MIL-PRF-19500/673
AMENDMENT 2
6 May 2002
SUPERSEDING
AMENDMENT 1
20 August 2001

PERFORMANCE SPECIFICATION

SEMICONDUCTOR DEVICE, FIELD EFFECT RADIATION HARDENED
(TOTAL DOSE AND SINGLE EVENT EFFECTS)
TRANSISTOR, N-CHANNEL, SILICON TYPES 2N7468U2 AND 2N7469U2
JANTXVR, F, G, AND H, AND JANSR, F, G, AND H

FIGURE 2. Thermal response curve. "

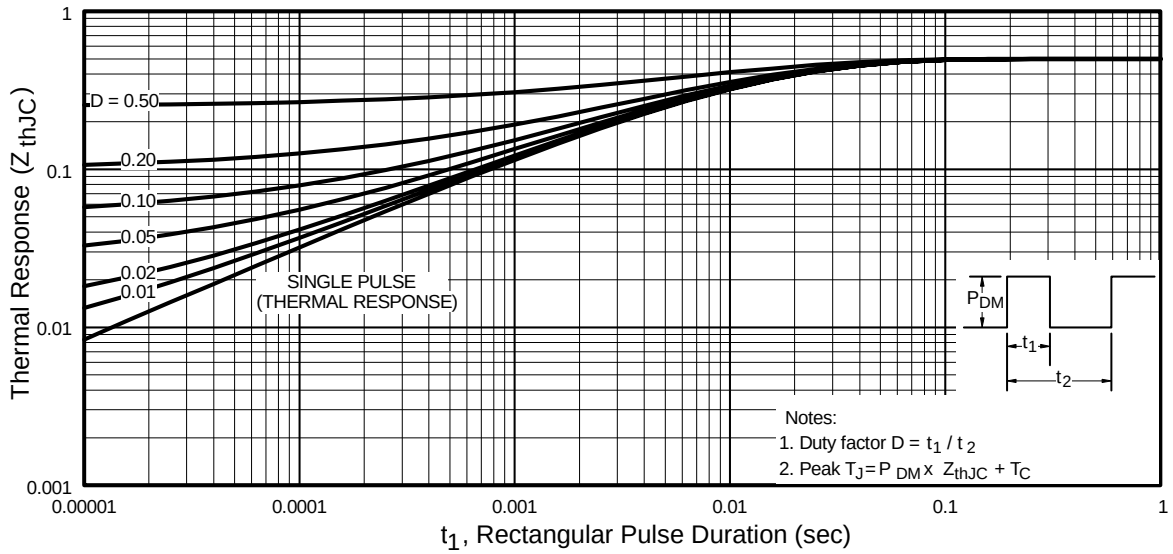
FIGURE 2, delete and substitute:
“

FIGURE 3. Safe operating area graph. "

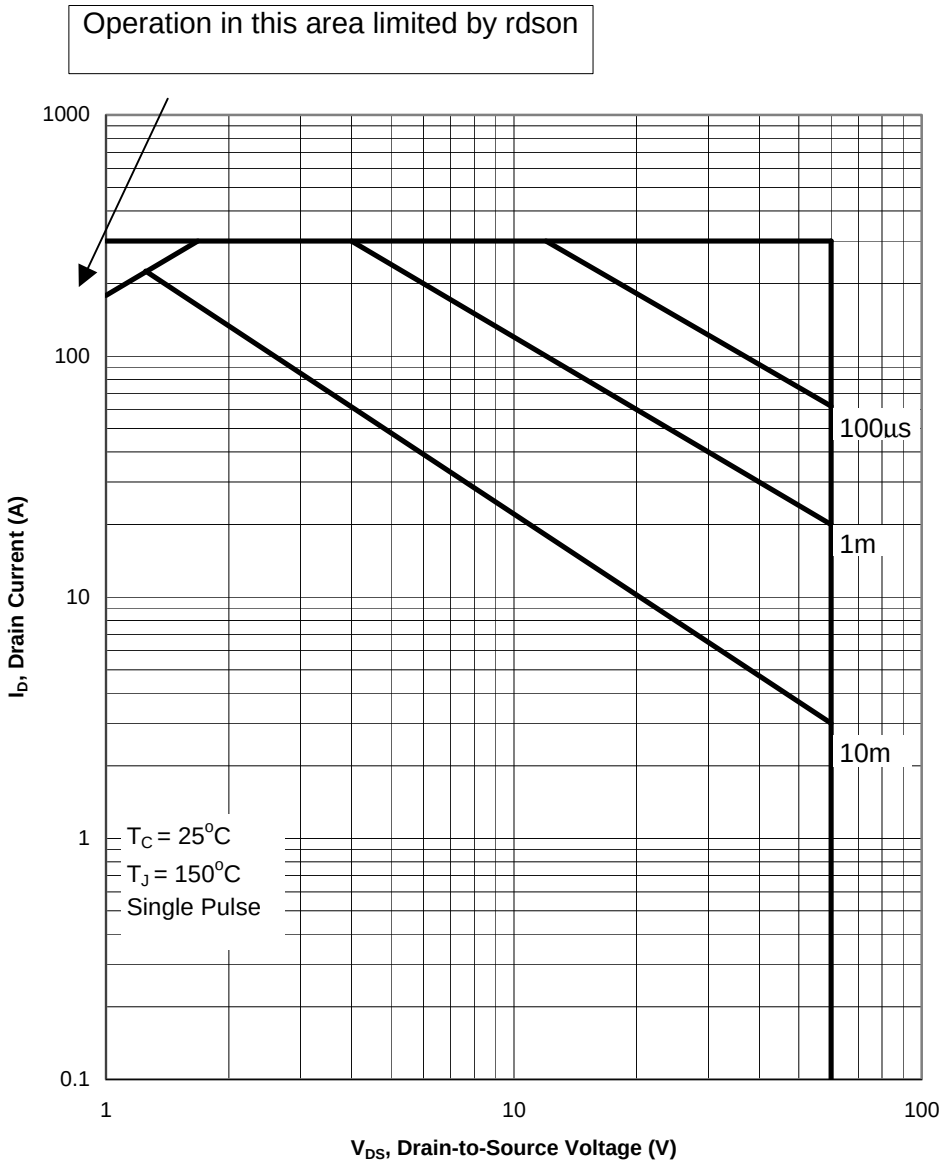
FIGURE 3, delete and substitute:
“

FIGURE 4. Safe operating area graph. "

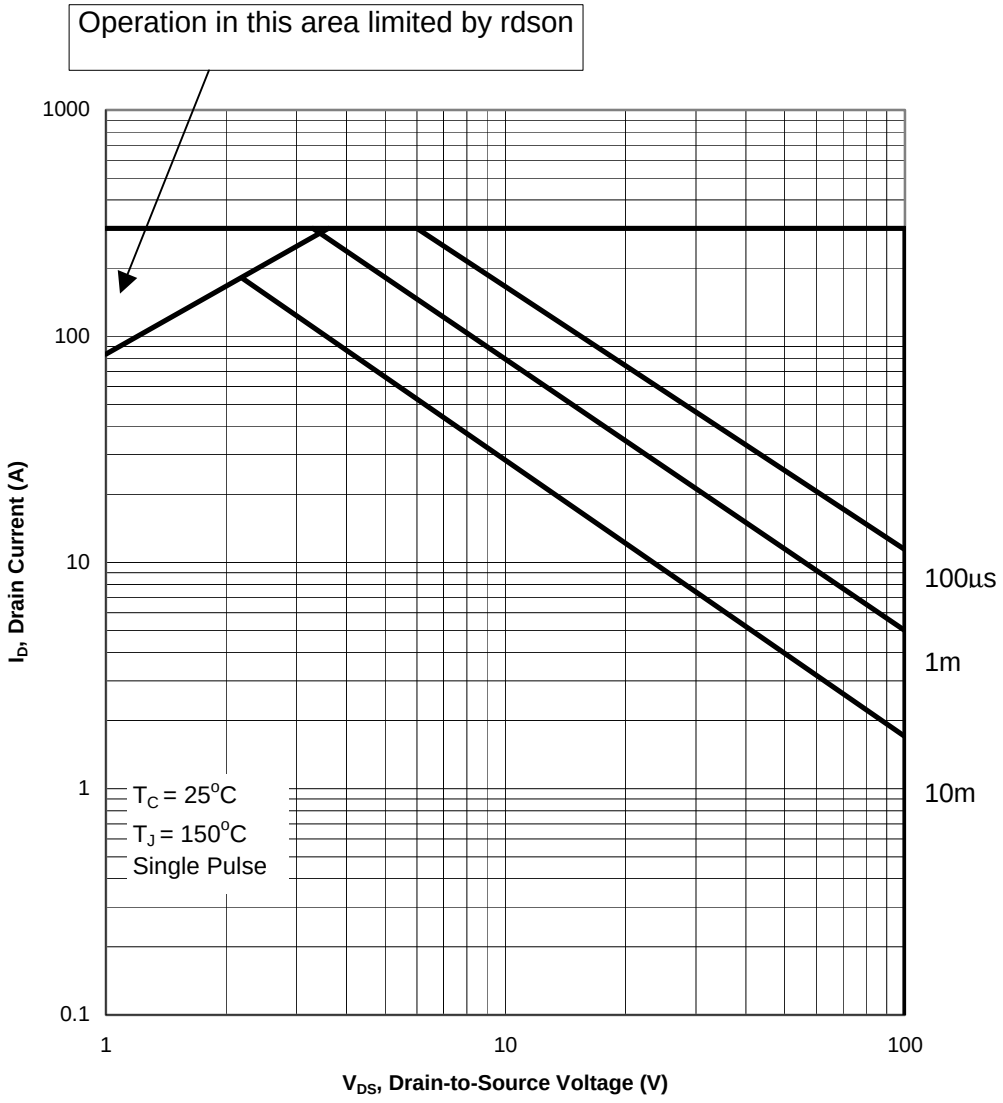
FIGURE 4, delete and substitute:
“

FIGURE 5. SEE safe operating area graph. "

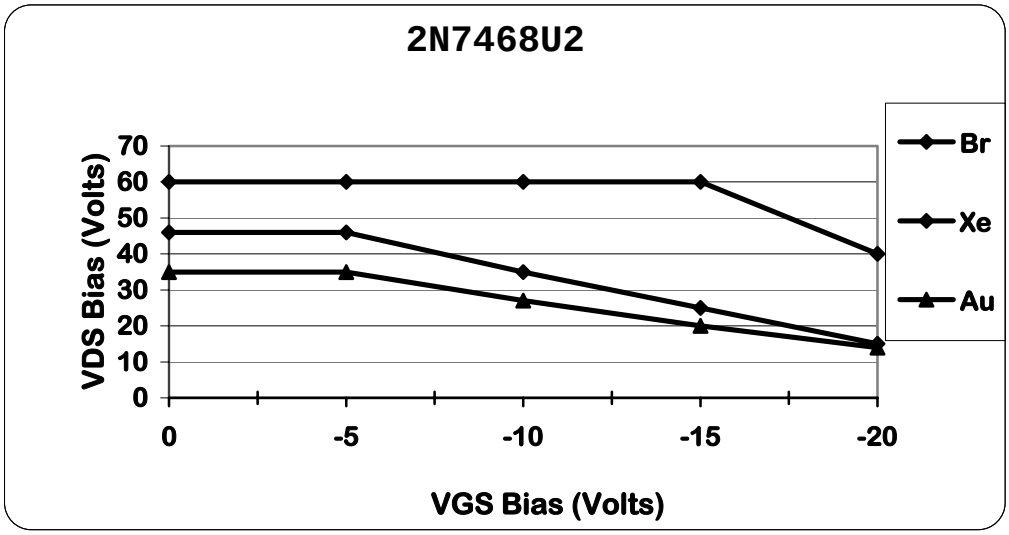
FIGURE 5, delete and substitute:
“
